## TRANSMITTAL FORM

**FROM:** Carrie O'Farrell, AICP  
**DATE:** November 15, 2023  
**PROJECT:** LIPA Medford Operations Center  
**NPV No.:** 08204  
**REF:**

**Re: LIPA Medford Operations Center  
Compatible Growth Area Hardship Application  
N+P No.: 08204**

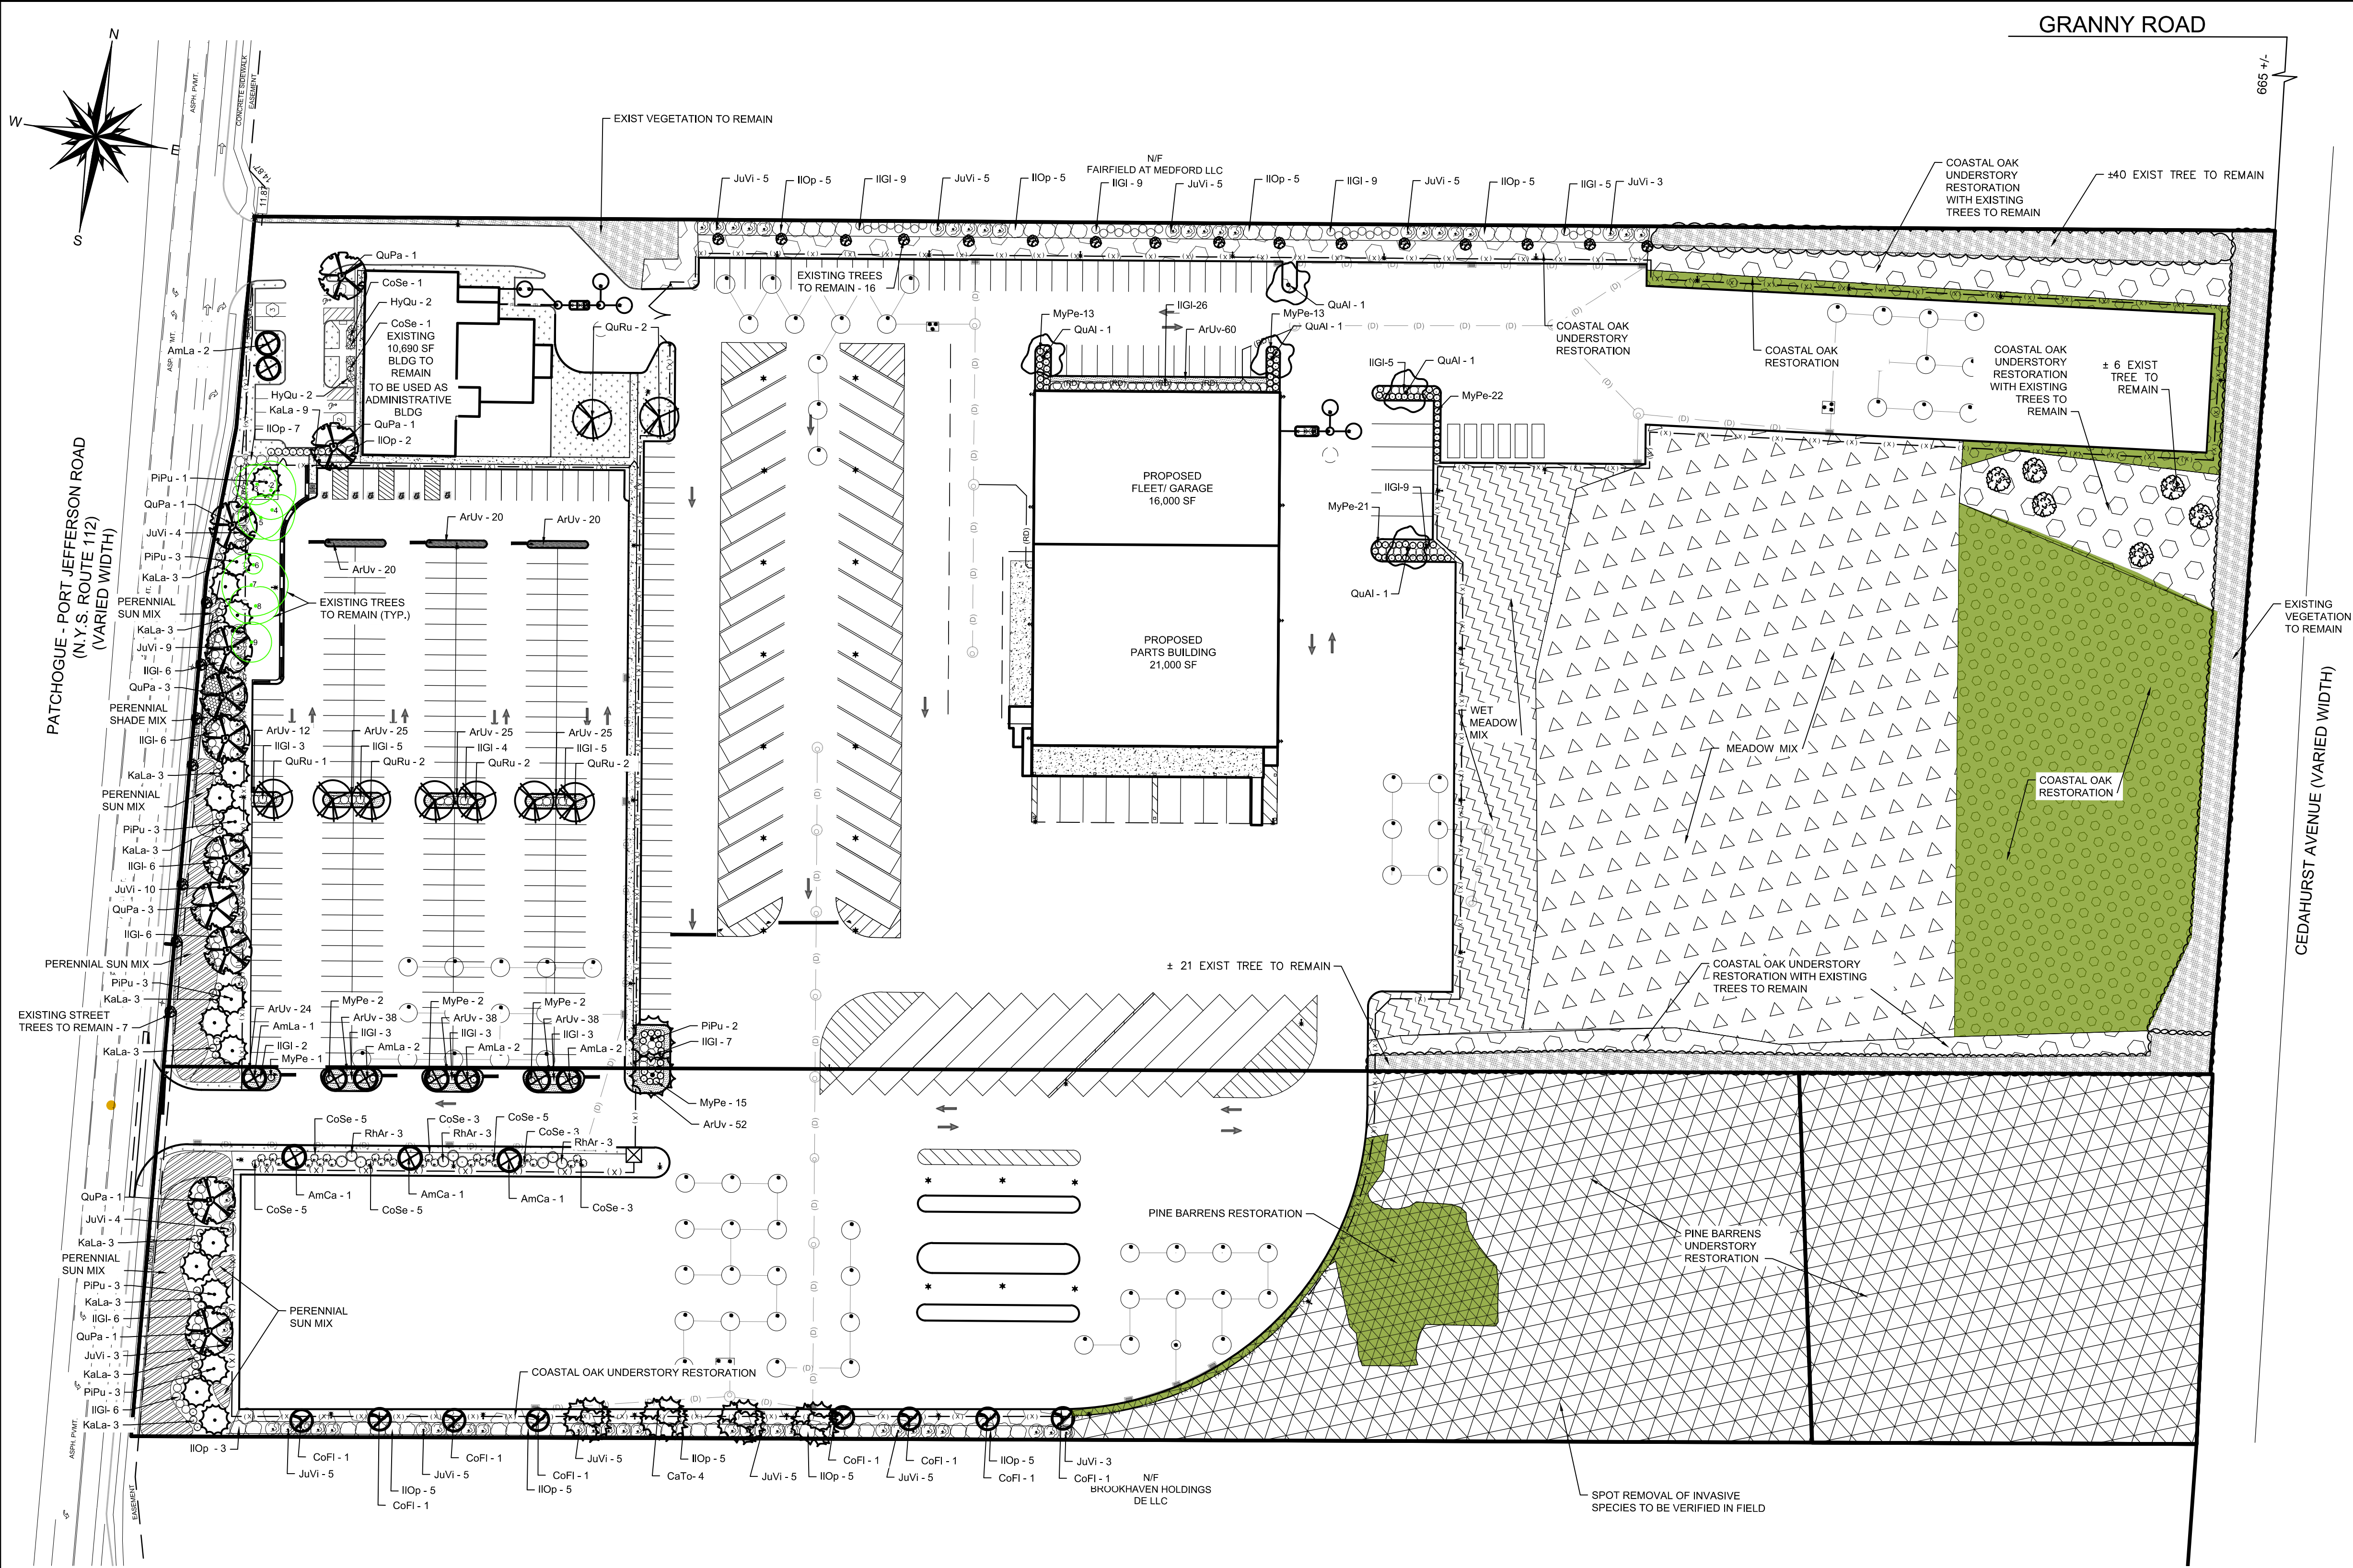
**COMMENT 5: Landscape Plan**

**a. Lists only 28,231 square feet of existing vegetation to remain. Please clarify, other statements in the application refer to approximately 4 acres of existing natural vegetation remaining.**

**b. Add more native oak trees and pitch pine trees to the landscaping plan.**

**Response:** *The 28,231 square feet of existing vegetation to remain is not inclusive of the wooded area to remain which is slated for targeted understory restoration, as illustrated on the Landscape Plan (Sheet LA-101). 134,071 square feet of existing poor quality woodland*

*Response: The landscape plan was designed with the advancement of natural processes in mind. In particular, it is acknowledged that woodland restoration takes time to fully mature. Ultimately, what is initially planted is intended to provide space for a mature and healthy woodland with adequate canopy space for mature trees, and provide the most opportunity for the trees planted to succeed. As the woodland matures, it is anticipated that trees will produce seed and additional seedlings will establish, and survival of said seedlings will be dependent upon the availability of resources. Further, over densification of forested areas contributes to fuel loads, and does not result in a balanced ecosystem. Therefore, no additional trees have been added to the Landscape Plan given the considerations outlined above.*
